REFERRAL REPORT

TO: Vancouver City Council
FROM: General Manager of Planning, Urban Design and Sustainability
SUBJECT: CD-1 Rezoning: 4745-4795 Main Street

This report evaluates an application to rezone the site at 4745-4795 Main Street. The application is for a mixed-use, six-storey building with a total of 89 secured market residential units with commercial spaces at grade. A height of 22 m (72.2 ft.) and an FSR of 3.7 are proposed, with a total floor area of 6,932.7 sq. m (74,623 sq. ft.). The rezoning application is being considered under the *Secured Market Rental Housing Policy (Rental 100)*. If approved, the application would contribute 89 secured rental housing units towards the City's housing goals as identified in the *Housing Vancouver Strategy*.

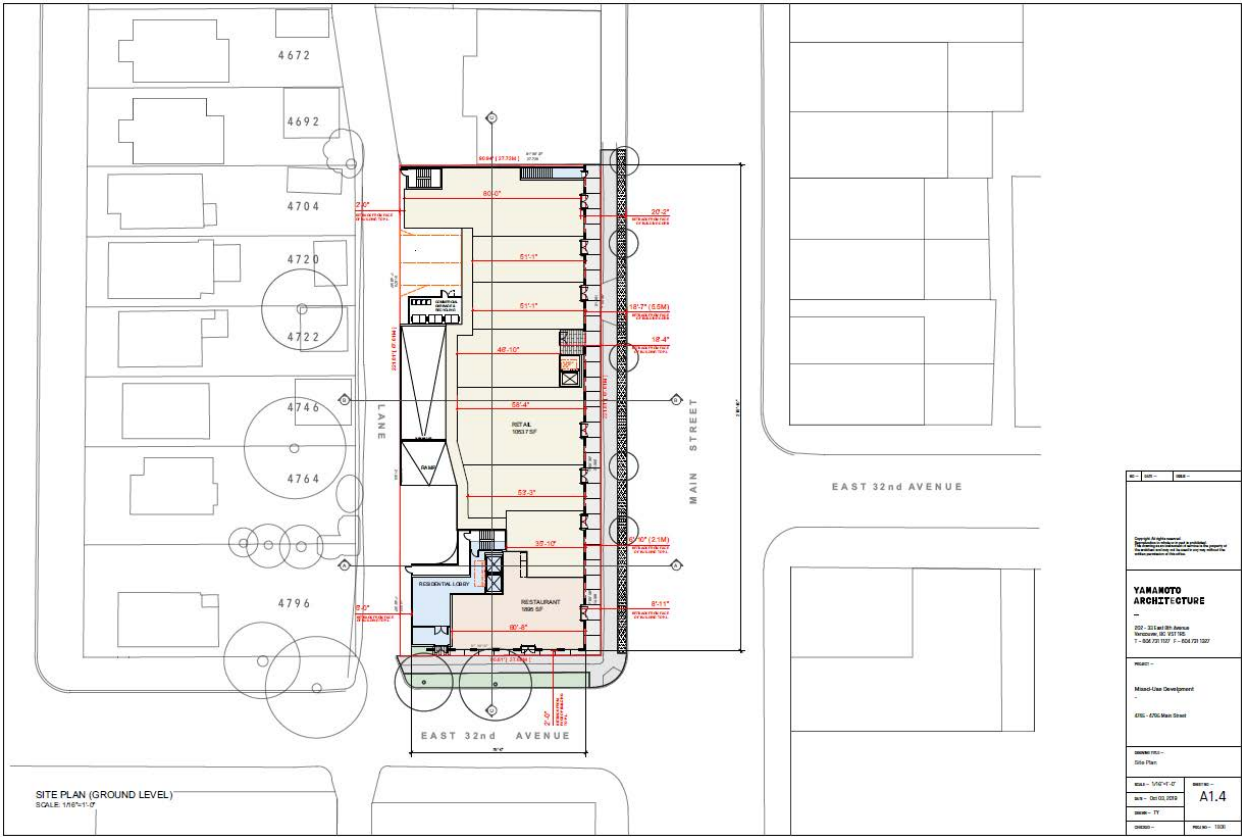
Insulation/windows – consider better performance. Consider passive cooling east – west and shading. Consider weather protection at the long level 5 decks like variation in balconies.

Residential entry needs to feel more garden like – more greenery, a canopy, bench, further set back from the street. It reads like a CRU rather than a residential lobby.

Review the retention of the existing street tree on 32nd Avenue. There is a concern that the building excavation is too close to the root protection zone, and the design relies heavily on the existing street trees to help soften the massing and contribute to the public realm.

Applicant's Response: The applicant team thanked the panel for their comments and will take the comments into consideration for further improvement.
